# 45 McLaren St

## North Sydney

Response to Council RFI

February 2024

Increase setback from southern boundary on SW corner podium to widen through site link to approximately 5.2m, which represents a 70% increase in the width of the link.

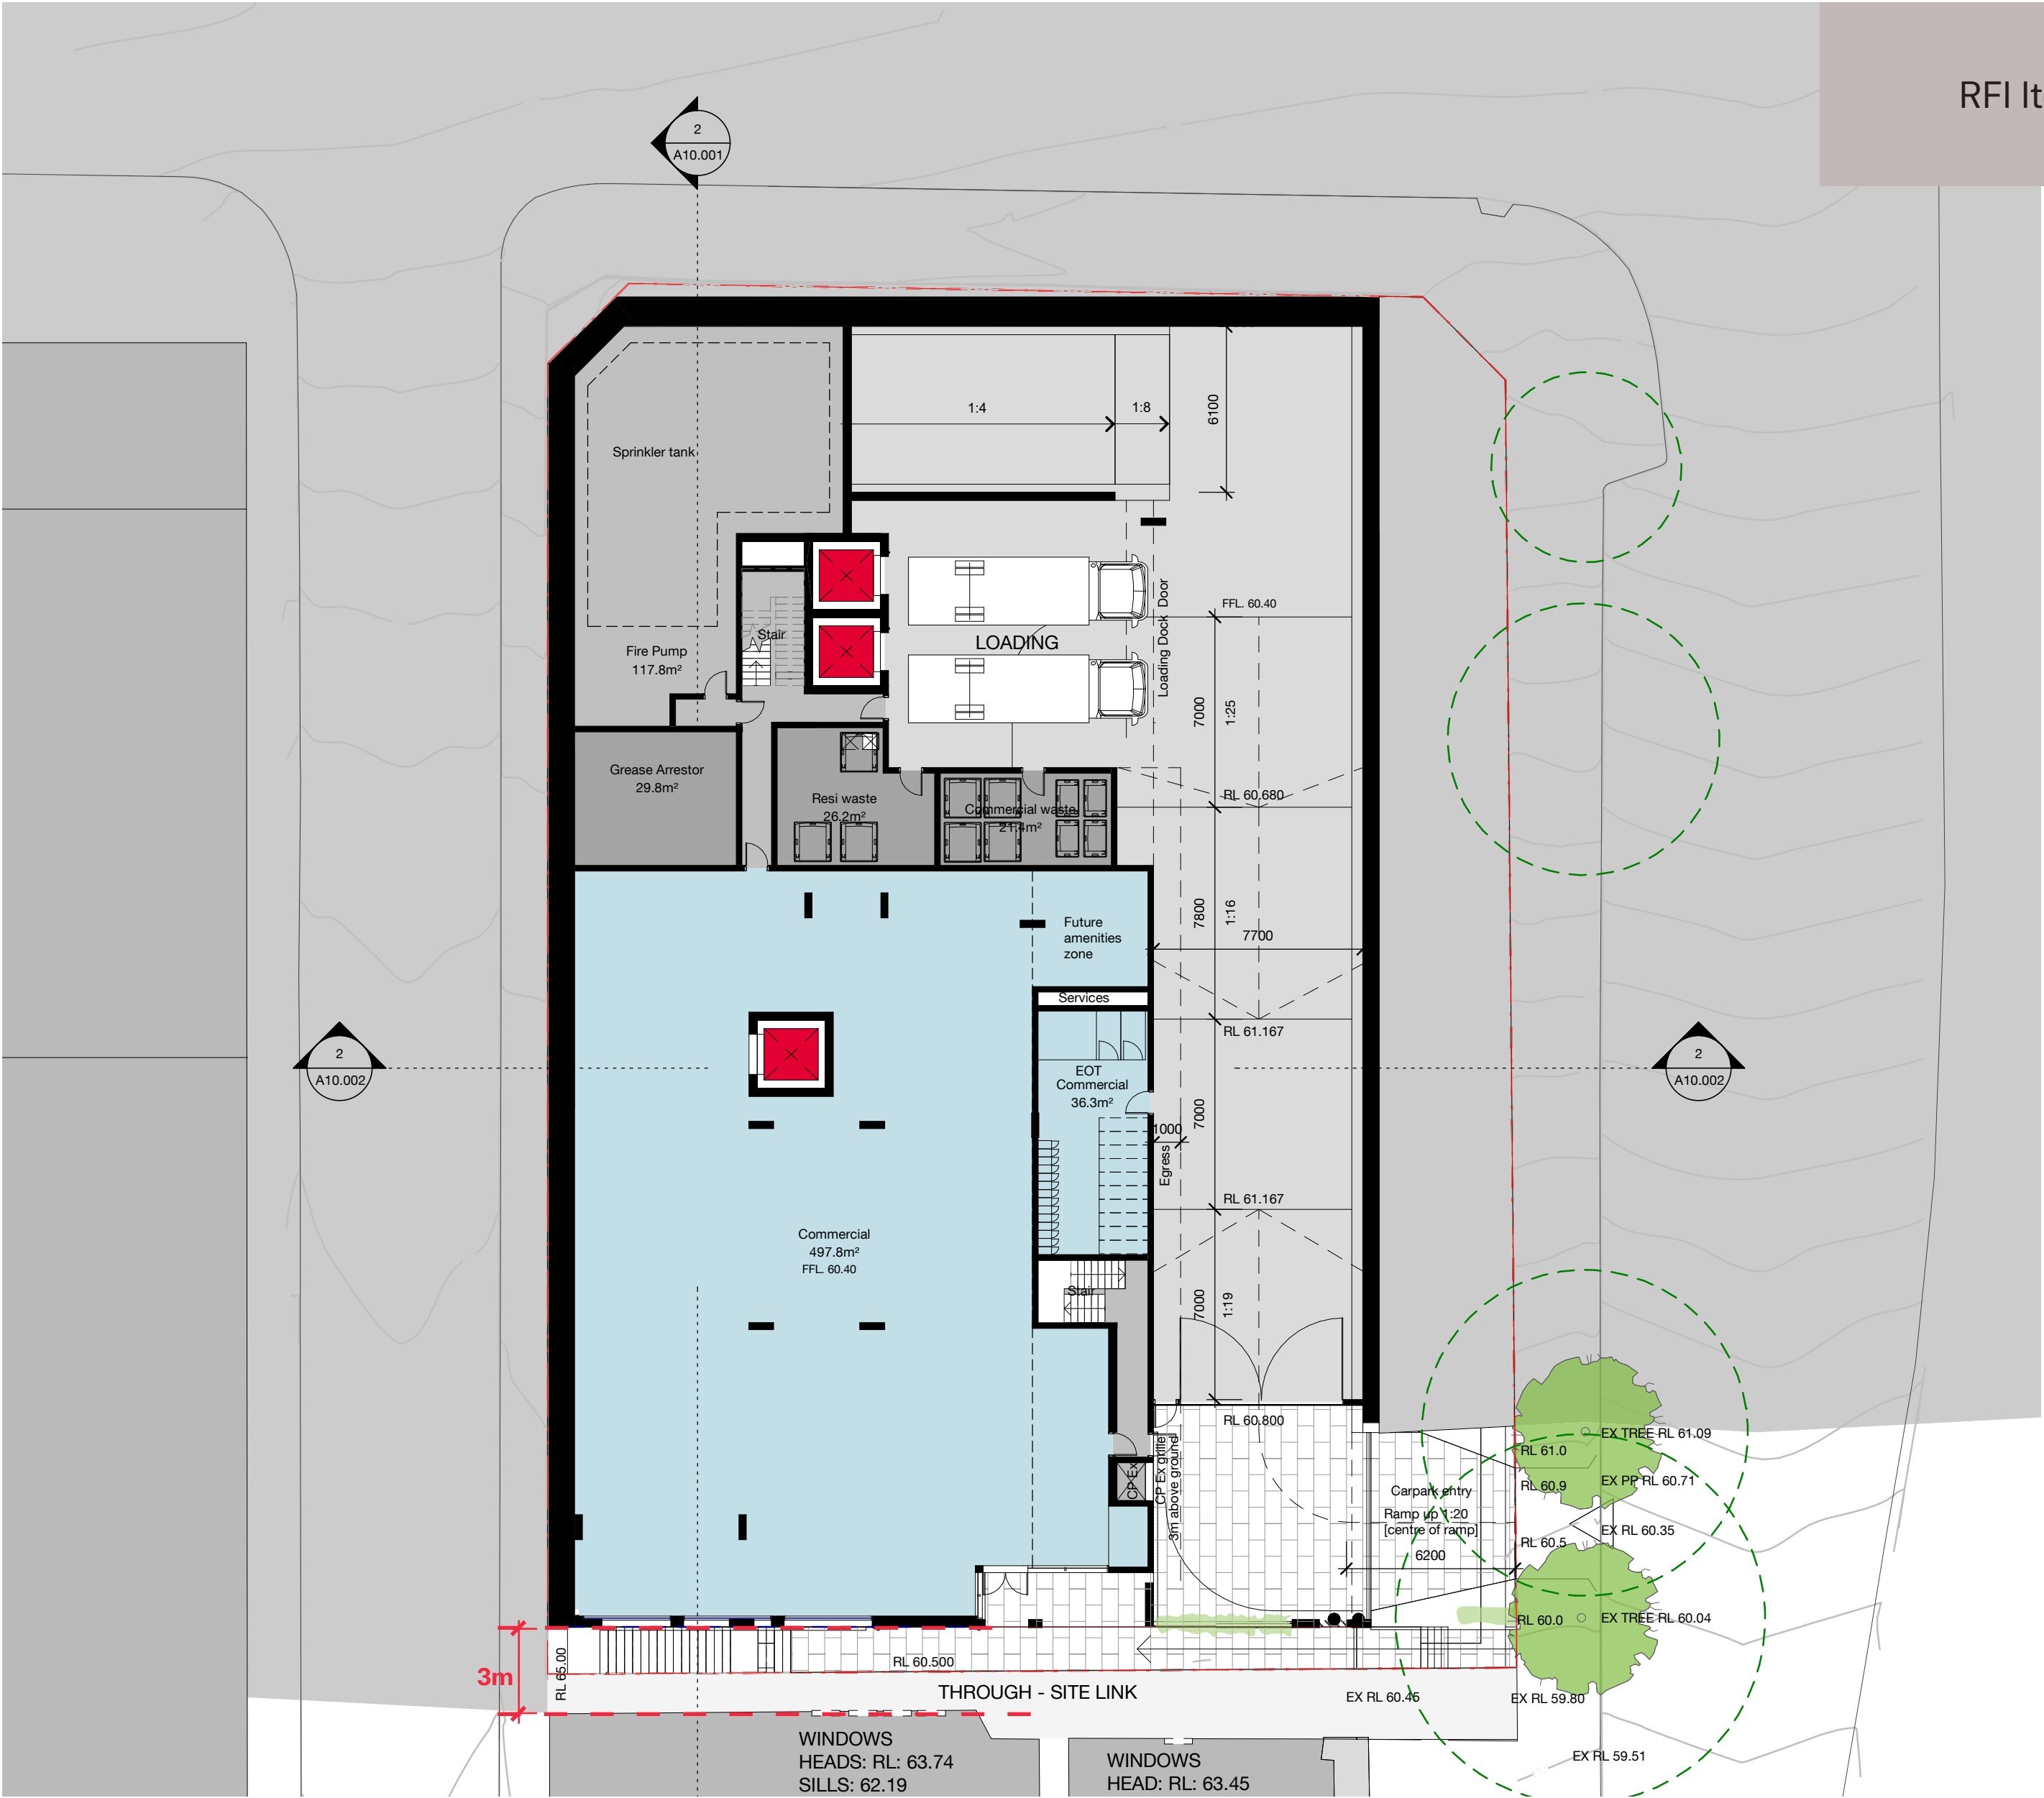
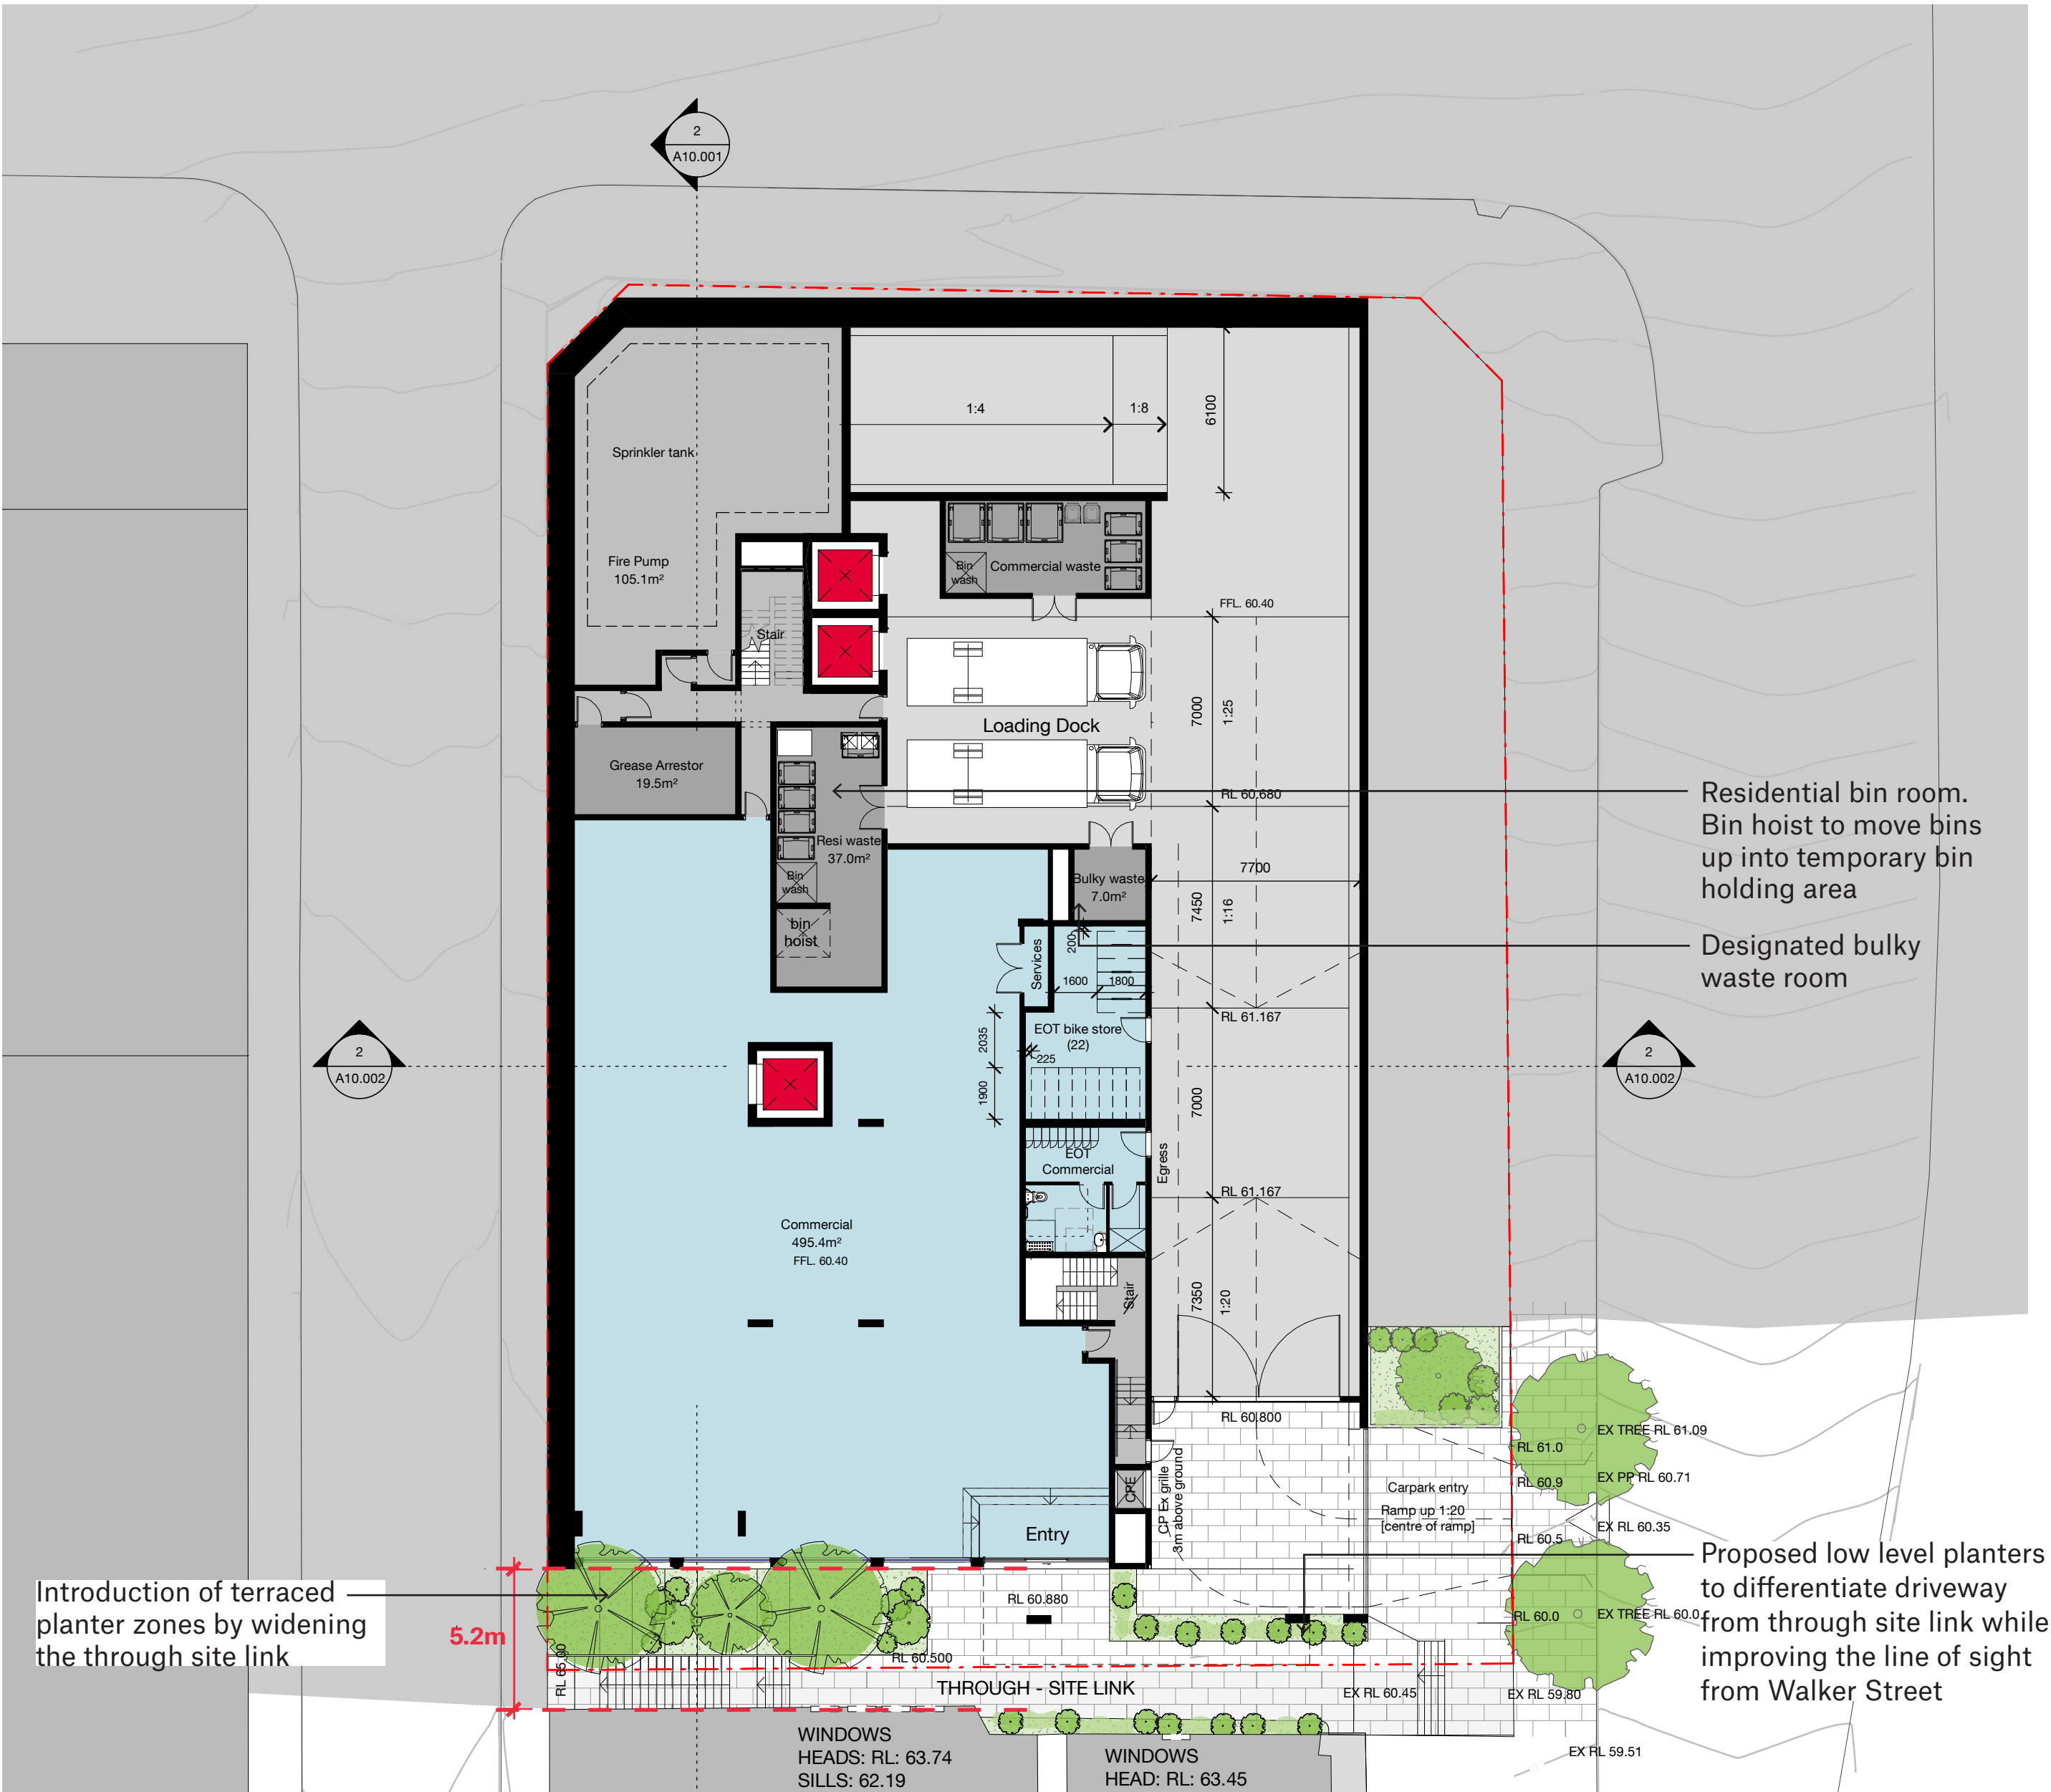
*The Panel observed that the **improved pedestrian path on the southern boundary** provides some community benefit. Opportunities to **increase the width of the through site link** to **improve passive surveillance and activation** of this space should be considered such as the creation of a small public space with natural light and air.*

*This would also substantially improve the amenity and functionality of the commercial tenancy on the lower ground floors.*

- Podium with 1.5m setback from Southern boundary to meet DCP setback requirement, seeking to widen the existing through-site link by doubling its width to 3m clear.

Low height planters are proposed along the driveway to differentiate but visually open up southeast corner from Walker Street and improve line of sight.

- More natural light and air to improve the amenity of the lower ground tenancy.
- Improved line of sight to through site link and improve passive surveillance with more street activation - making through site link feel more inviting.
- Introduce terraced deep planters which allows additional trees along public through site link and soften the building at its edge.
